Kane Commons

PROJECT DESCRIPTION AND STATEMENT OF INTENT

Amendments to Detailed Plan Development Phase 2

PLEASE SEE ITEMS IN RED FOR AMENDMENTS TO THE DEVELOPMENT PLAN

IMAGE OF GARAGE DOOR

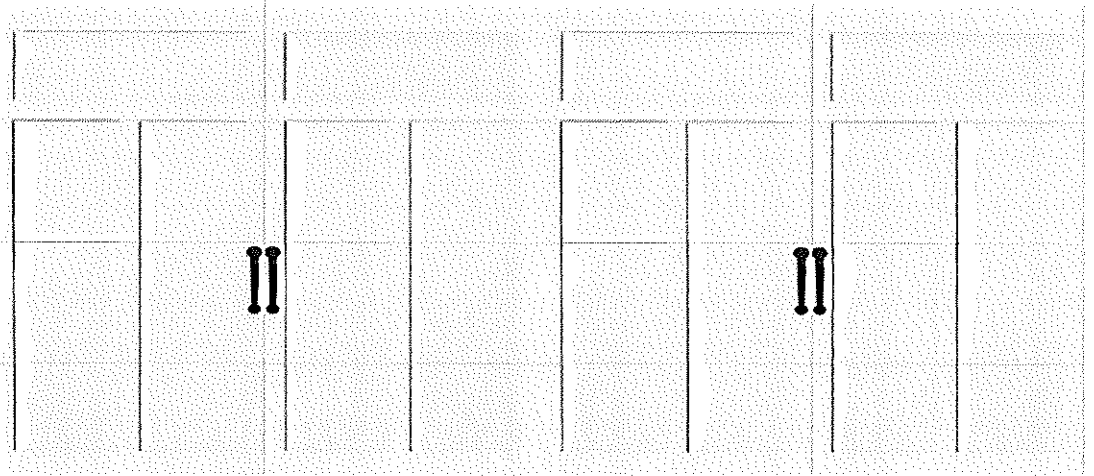
5. The eastside building setback for 1168-1170 will be 1-6". This will match the set back on the west side of the development
6. 1170 East Kane will have a double garage door on the street. See attached drawings for style
